January 20, 2004 CPC

STAFF'S
REQUEST ANALYSIS
AND
RECOMMENDATION

04PR0201

NPR Group, L.L.C.
(Grand Oaks Apartments)

SHEET 3.3

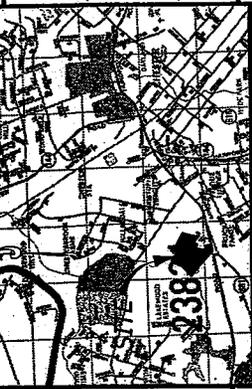
30. On Sheet C3.3 remove the portion of the note, regarding the emergency access road, that indicates that "signage denoting the emergency access road is optional and at the discretion of the homeowners association". The signage is required. A note to that effect shall replace the deleted portion referenced above. Additionally, provide a graphic of the "Fire Department emergency access road only," indicate colors and letter size. (F)

93. Revise the building types shown on Sheet C3.2 for senior housing to match the revised types five (5) and six (6), per the architectural plans. (P)
94. Remove the note above the gate detail on Sheet C3.3 as it does not apply. Verify that the gate dimensions will work for a road width of twenty-four (24) feet. Provide a substitute note, if required by Fire. (P)

SHEET 3.1

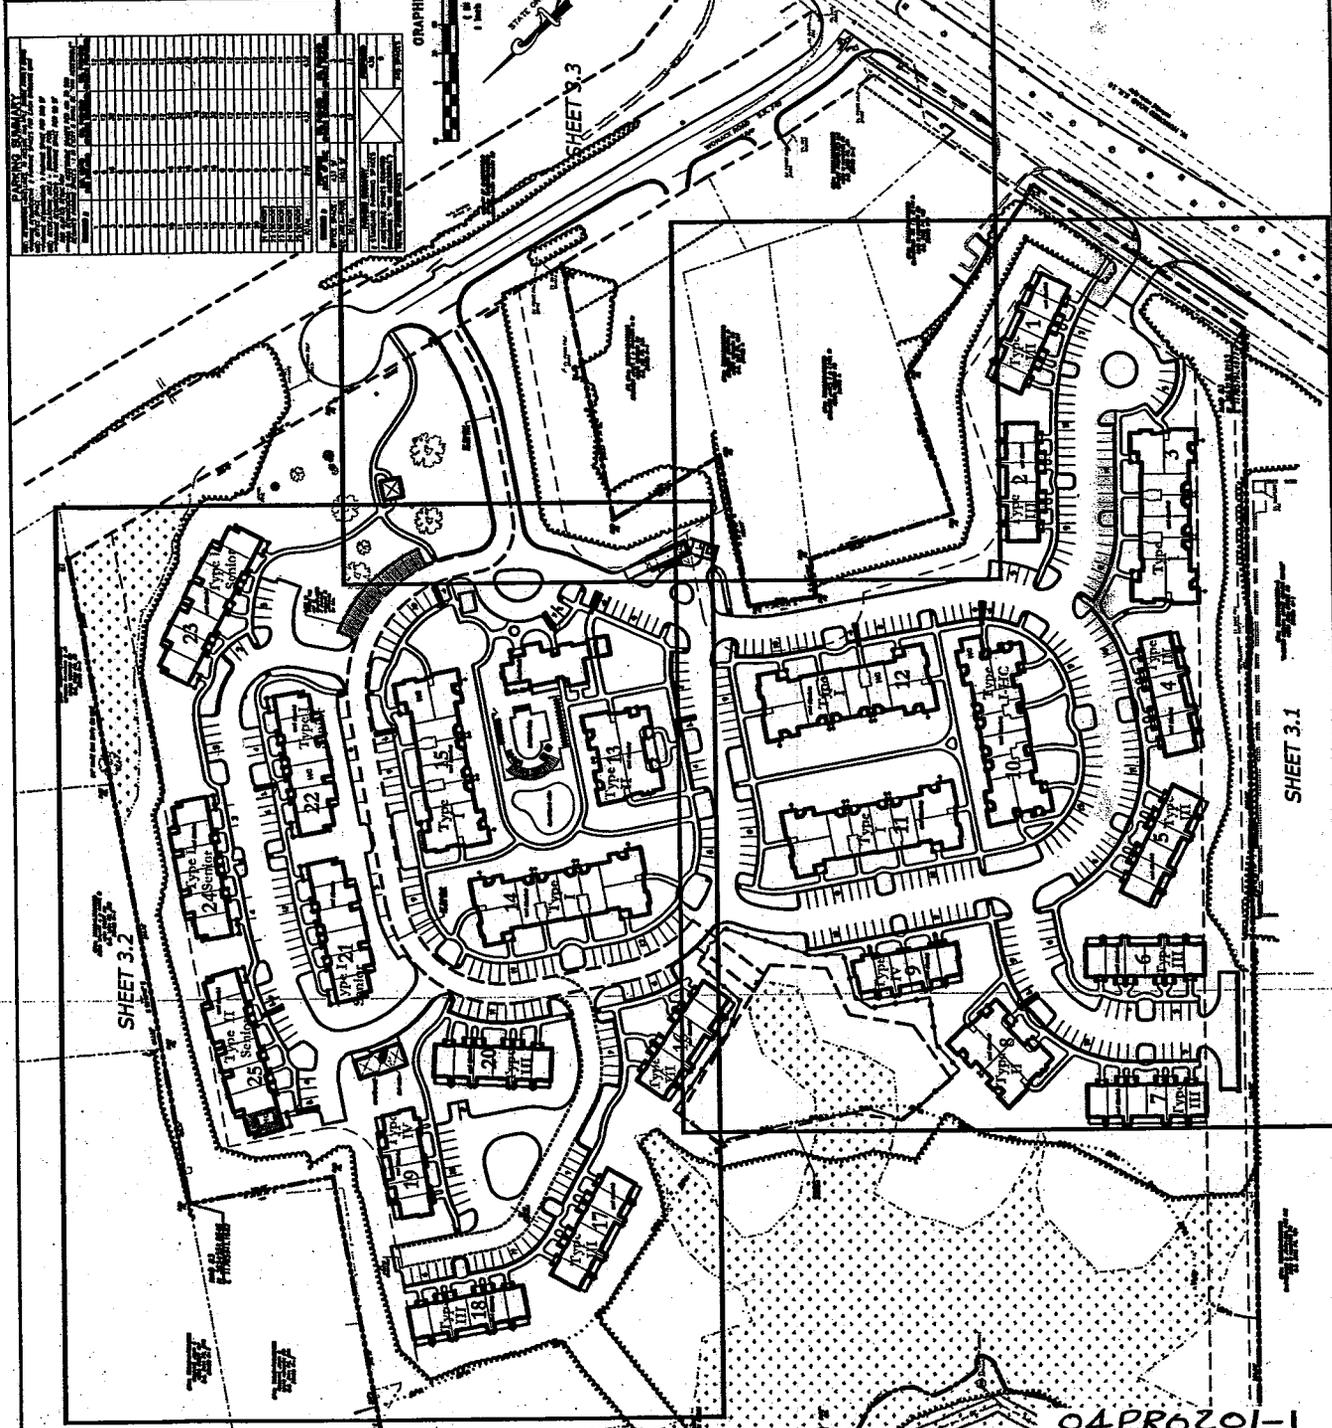
29. Additional fire lane marking shall be provided in the following areas: (a) Sheet C3.1 - at the landscape parking circle adjacent to Building 1, (b) Sheet C3.2 - at the circle area adjacent to the clubhouse building. (F)

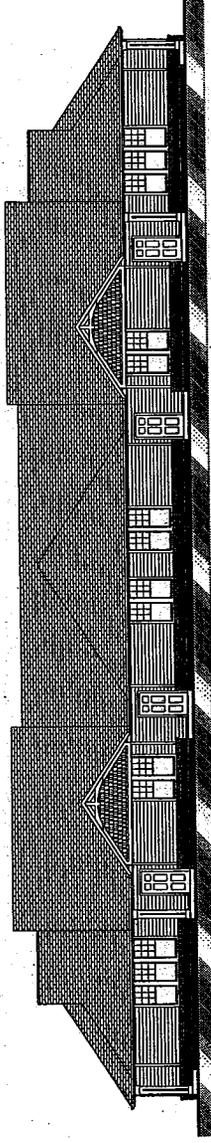
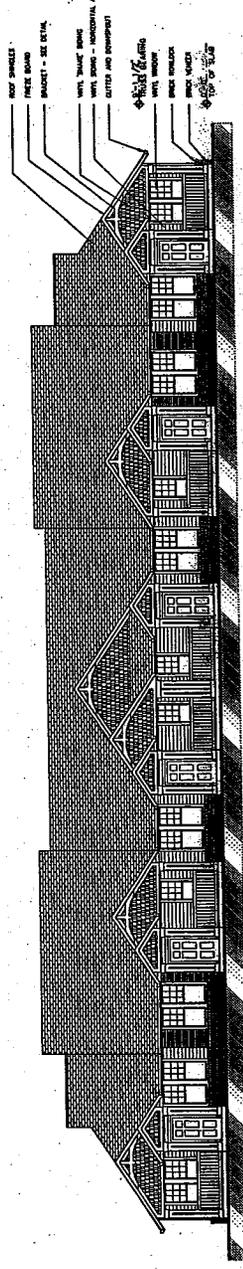
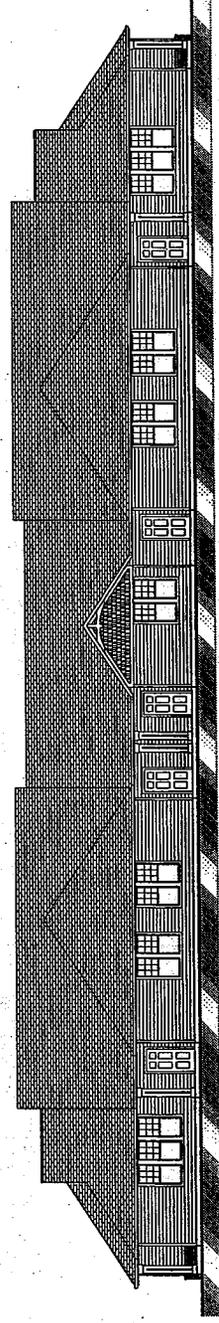
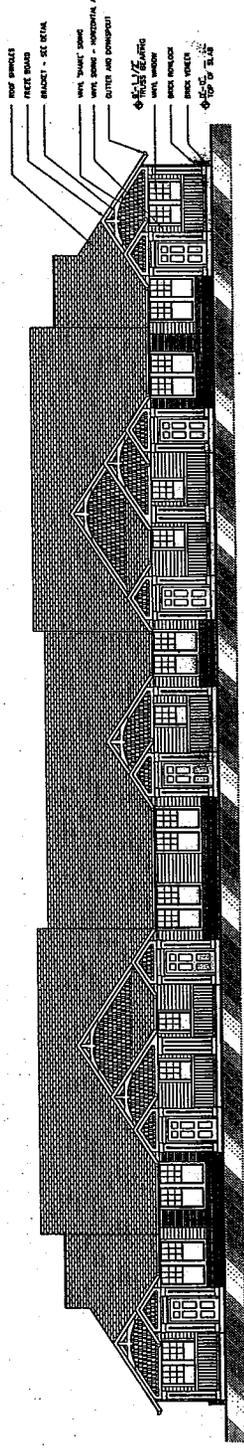
101. The revised architectural elevations require additional information, such as siding colors and roof shingles (should be dimensional shingles) and additional brick or details to meet the architectural style per the proffered condition. Provide details of common elements such as columns and brackets. Provide partial elevations or text explanations of areas not shown in the elevations provided to provide information for inside corners. (P)

102. Some of the architectural elevations do not appear to match the floor plans. As an example the rear elevation indicates four (4) columns on building type one (1) that do not seem to be indicated on the floor plans. A roof line and gable end are not indicated in the side/courtyard elevation. Revise. (P)

Sheet **L13**

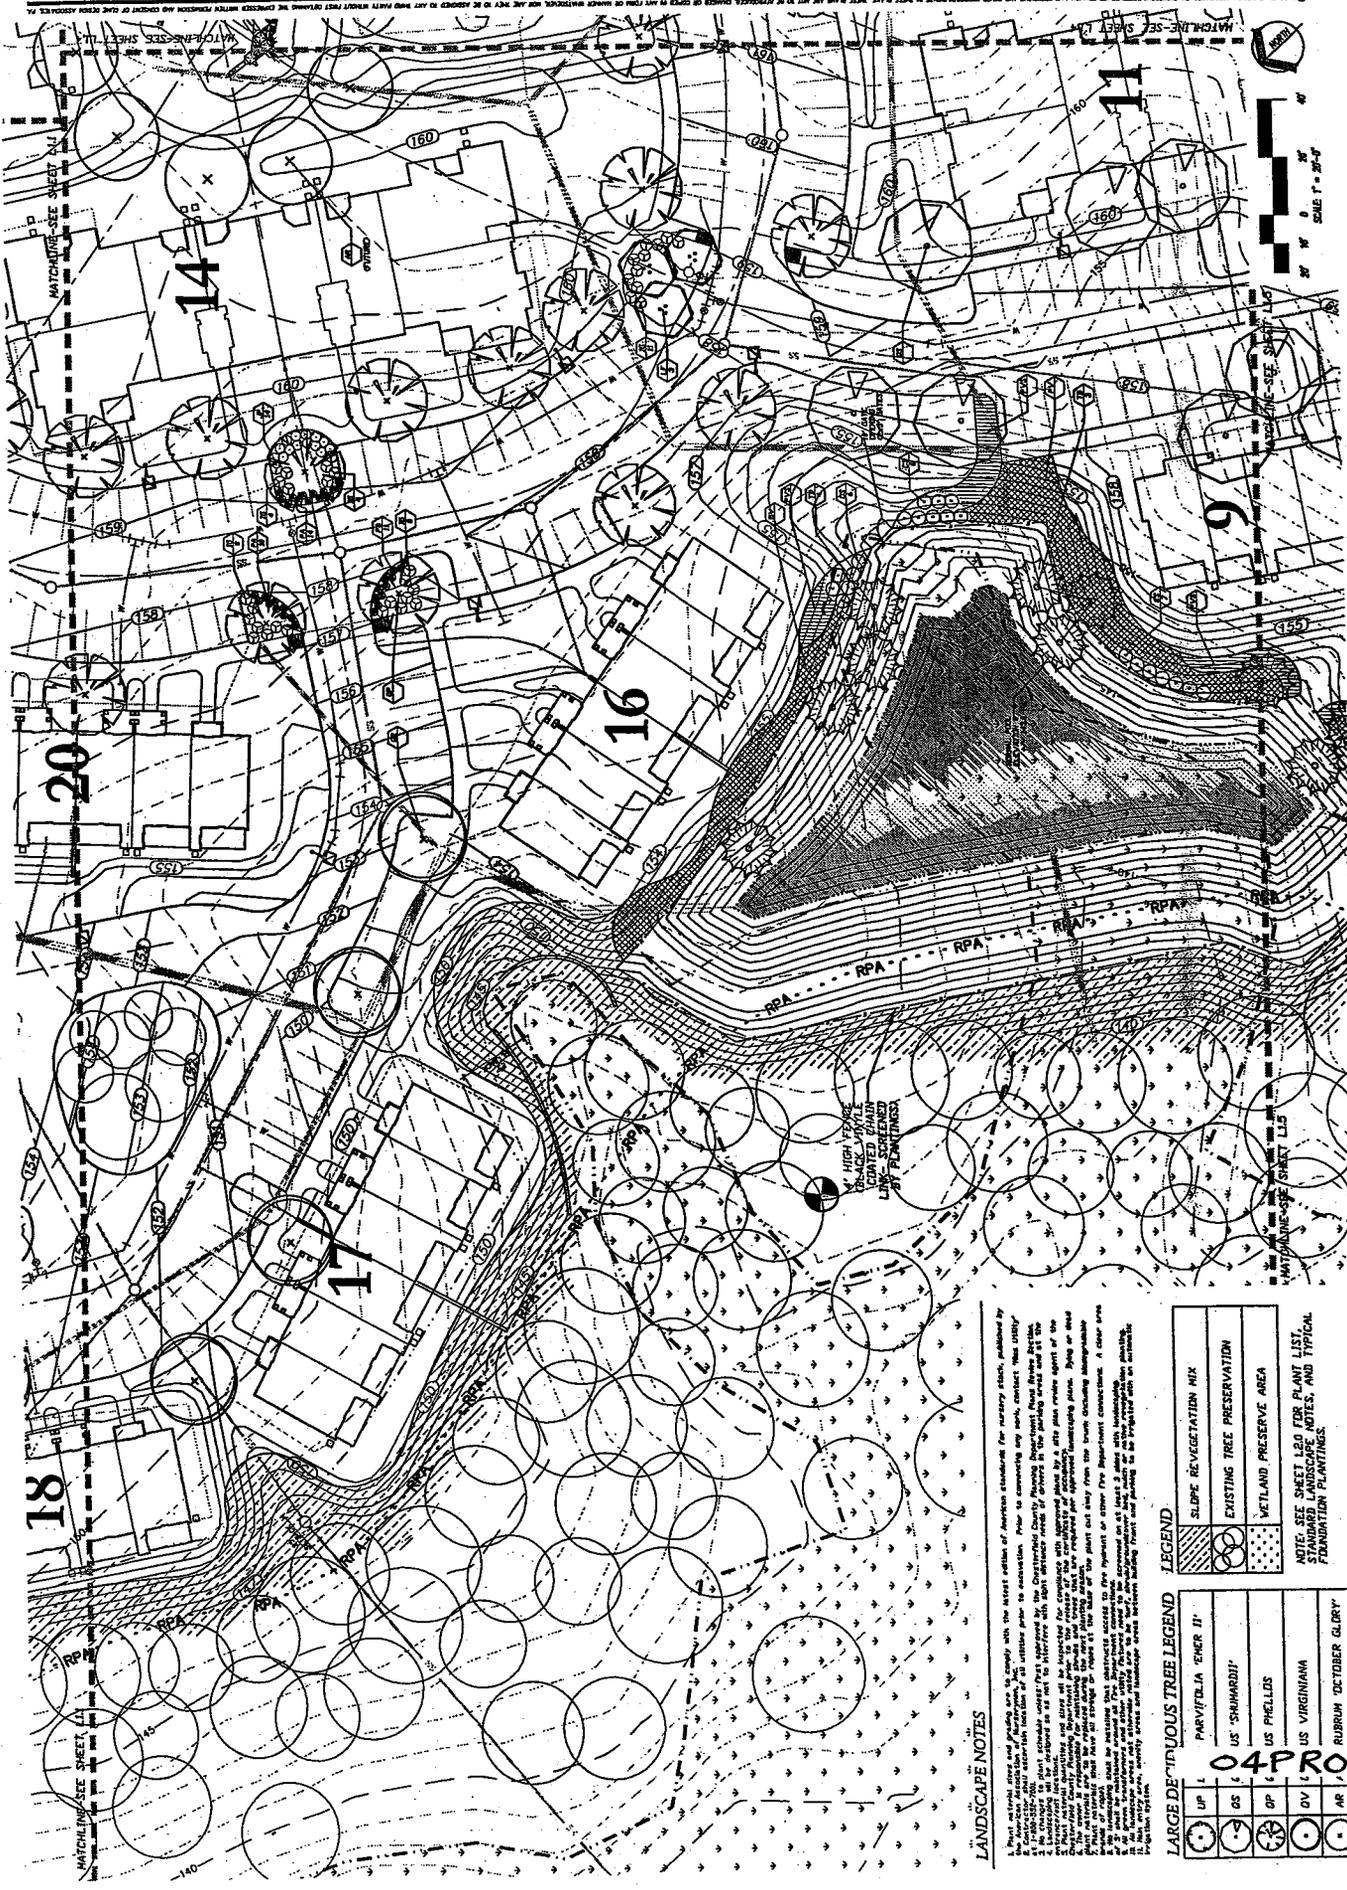
108. The plant label "LM," shown on the Route 10 Planting Plan on Sheet 11.0, does not match a tree in the plant schedule. Correct. (P)
109. Revisions to the Route 10 Planting Plan may be required upon review by VDOT or due to final resolution of final road configuration. (P)
